Certified Action of the City of Raleigh Planning Commission

Case File / Name: SP-11-2010 / Dragonfly

Nature of Case: This request is to approve a preliminary site plan for the conversion of an existing 2,505 square foot building from a bicycle shop to a restaurant on a .058 acre site, zoned Industrial-2 and Pedestrian Business Overlay District. This site is located within 400 feet of a residential use or zone.

SP-11-2010 / Dragonfly – Preliminary Site Plan

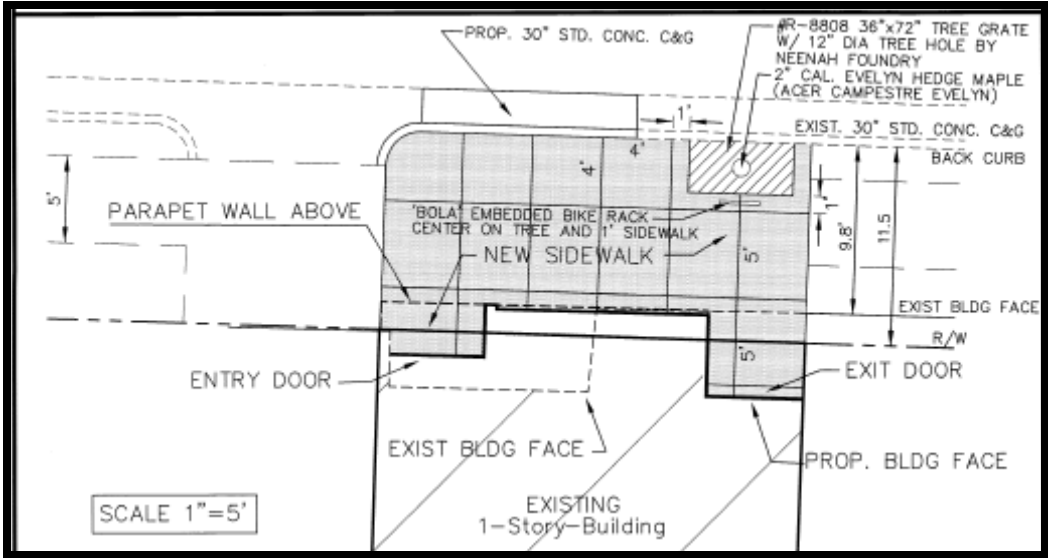
Comment	Response
Consider using a more durable material than hardipanel for the egress door and surrounding surfaces, to reduce impacts to appearance from eventual wear and tear.	This is an out-swinging exit-only door and with no exterior hardware, used as a secondary means of emergency egress for the building. Hardipanel is a cementitious material which we feel should stand up better than a painted hollow metal door. We feel it will be more maintenance free and the reveal system allows for the panels to be easily replaced in the unlikely chance they become damaged.
